Drawing Change List

HP-2-ASED-ID-0081-09-0C: CRYOSTAT HARNESS CVV EXTERNAL CCH and SIH

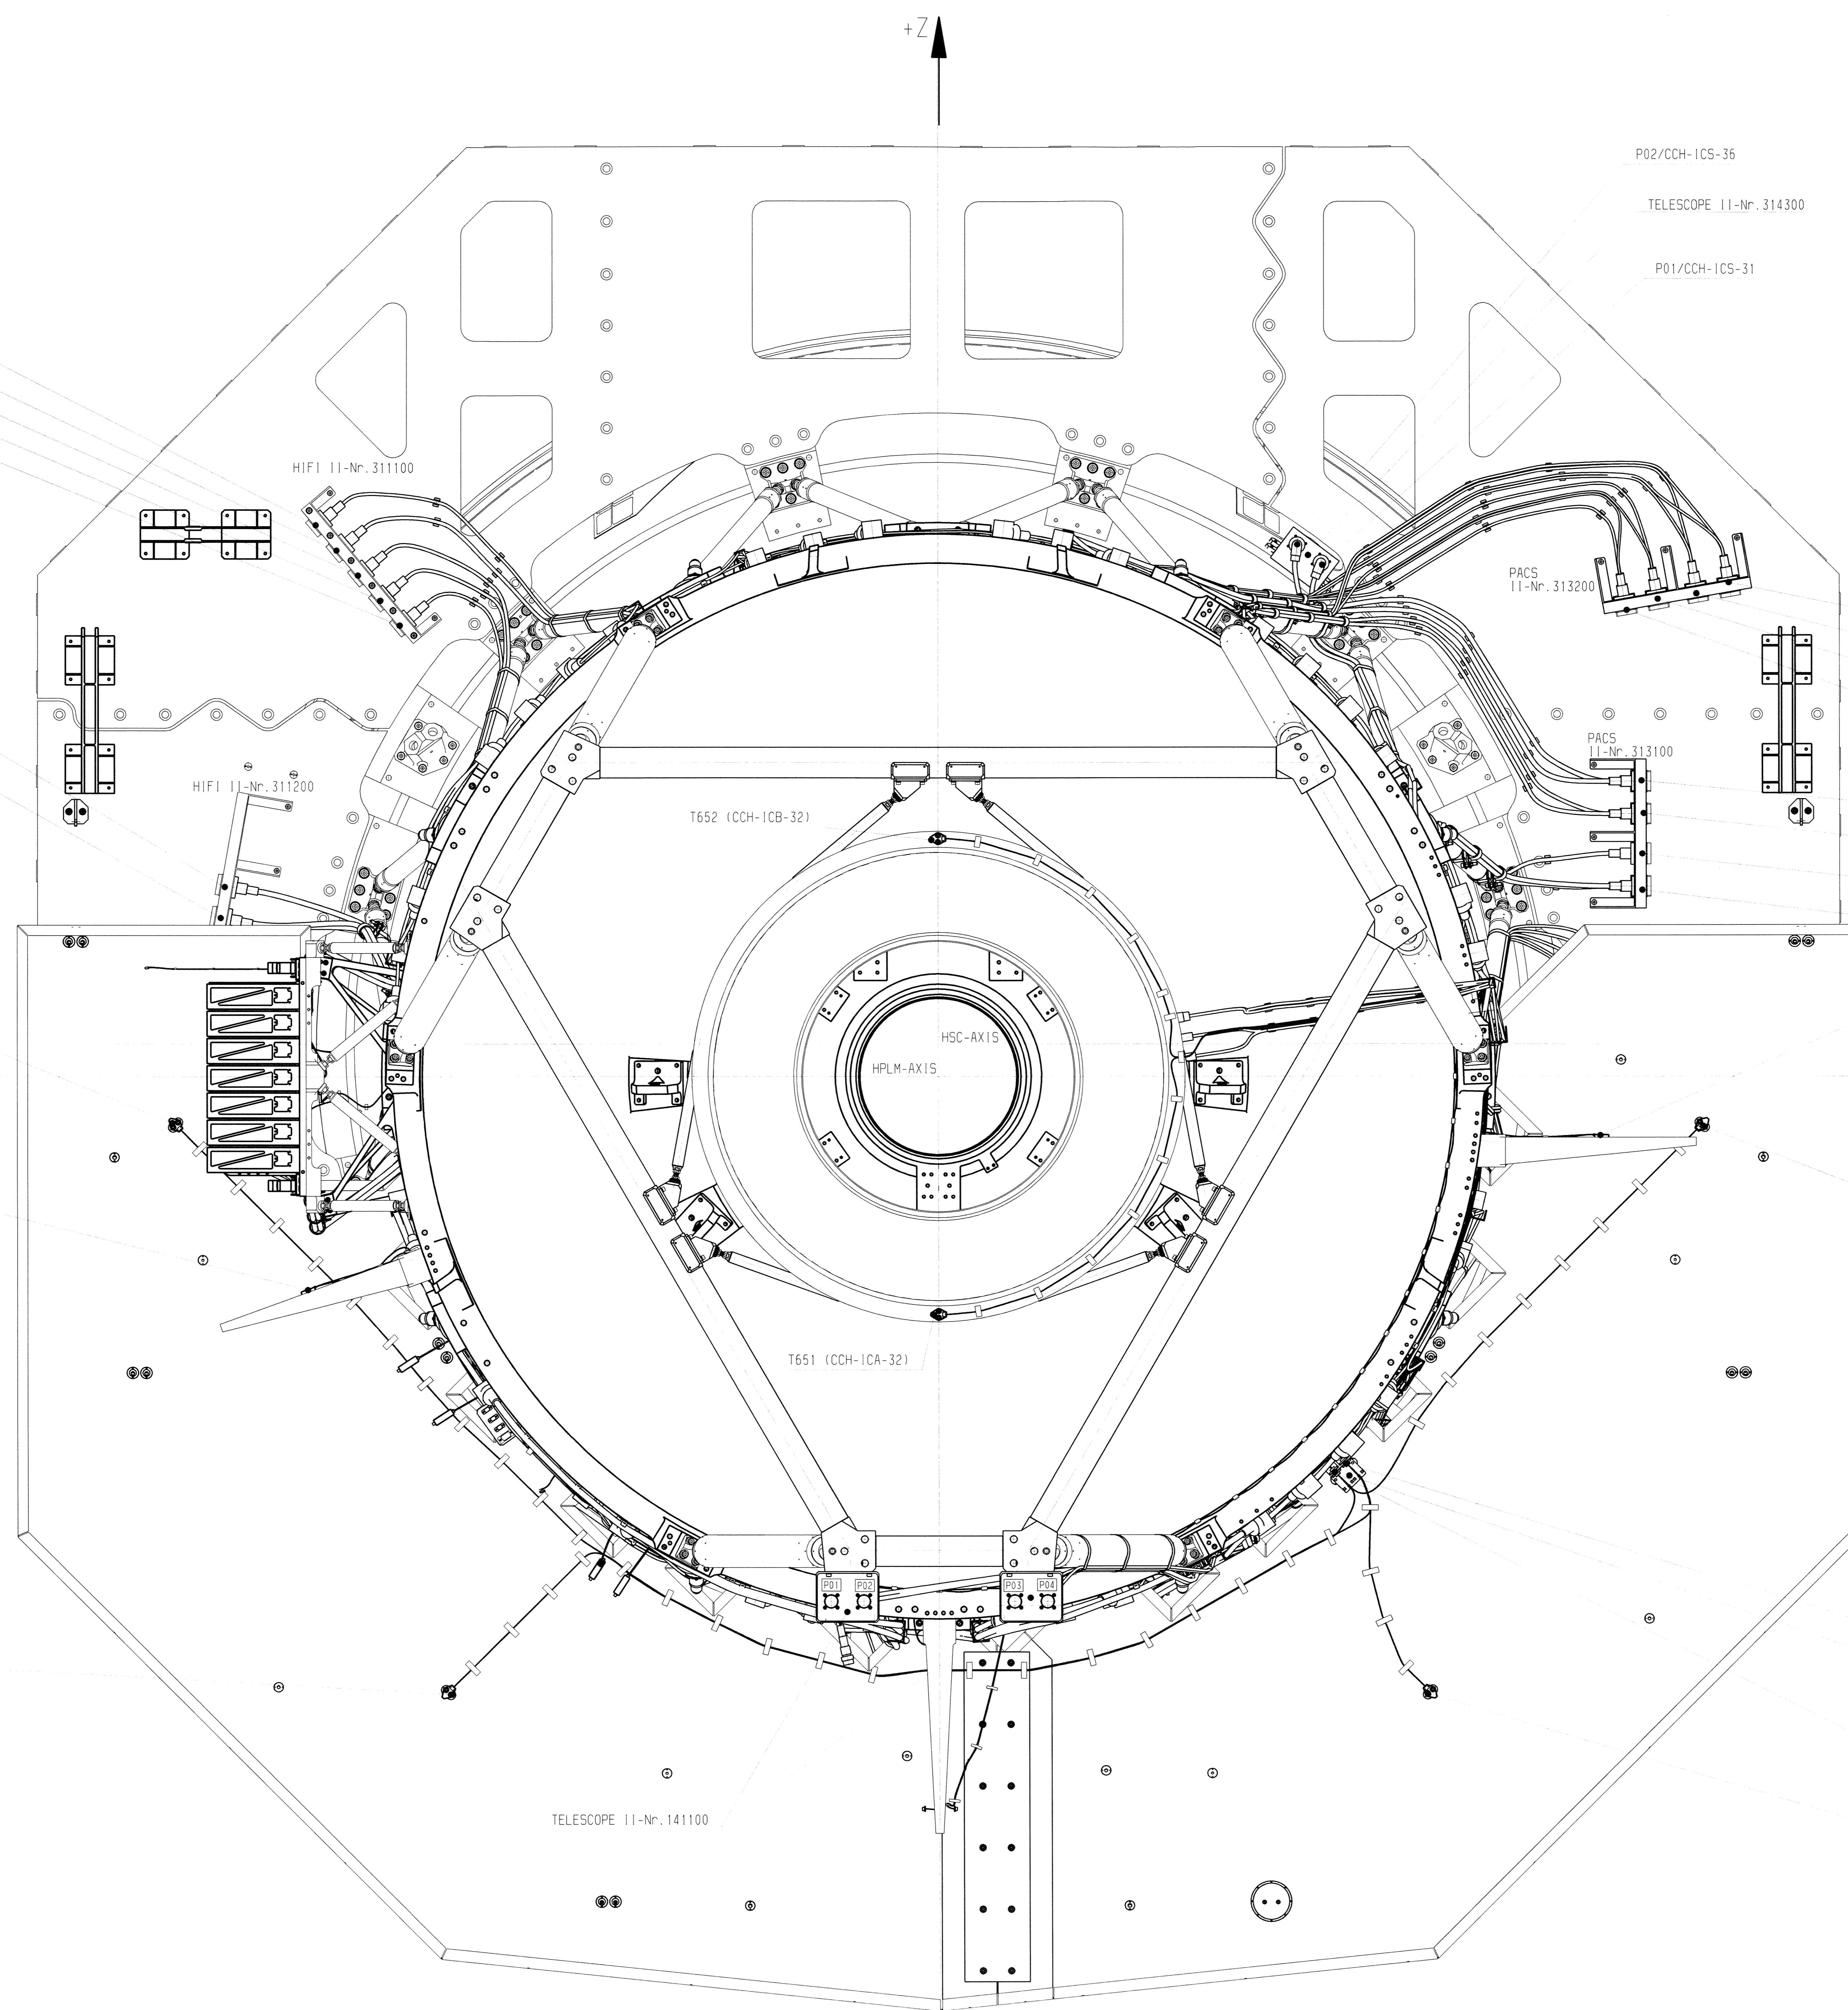
Related Drawing Section	Objective	Grid location	Actual Status Issue C	Previous Status Issue B
VIEW +Y+Z	Text changed	G15	Text changed : T324 (CCH-ICB-41)	T324 (CCH-ICB-32)
VIEW +Y+Z	Text changed	C14	Text changed : T323 (CCH-ICA-41)	T323 (CCH-ICA-32)
VIEW +Y+Z	Text changed	B4	Text changed : T322 (CCH-ICB-41)	T324 (CCH-ICB-32)
VIEW +Y+Z	Text changed	E3	Text changed : T321 (CCH-ICA-41)	T323 (CCH-ICA-32)
VIEW +Y+Z	new Text	B10	Telescope II-Nr. 141100 (HRN routing also implemented)	
VIEW +Y+Z	Text changed	J15	Text changed : J05/not used	J06/SIH-IH-11
VIEW +Y+Z	Text changed	J15	Text changed : J06/SIH-IH-08 (HRN routing adapted)	J06/SIH-IH-11
VIEW +Y+Z	Text changed	J15	Text changed : J07/SIH-IH-09 (HRN routing adapted)	J07/SIH-IH-10
VIEW +Y+Z	Text changed	J15	Text changed : J08/SIH-IH-12 (HRN routing adapted)	J07/SIH-IH-09
VIEW +Y+Z	Text changed	C4	Text changed : J02 CCH-ICB-41 (T322 and T324) P02 CCH-ICB-32	P02/J02 CCH-ICB-32 (T322 and T 324)

VIEW +Y+Z	Text changed	C4	Text changed : J01 CCH-ICA-41 (T321 and T323) P01 CCH-ICA-32	P01/J01 CCH-ICA-32 (T321 and T 323)
VIEW +Y+Z	new Text	H10	T652 (CCH-ICB-32) (HRN routing also implemented)	
VIEW +Y+Z	new Text	E9	T651 (CCH-ICA-32) (HRN routing also implemented)
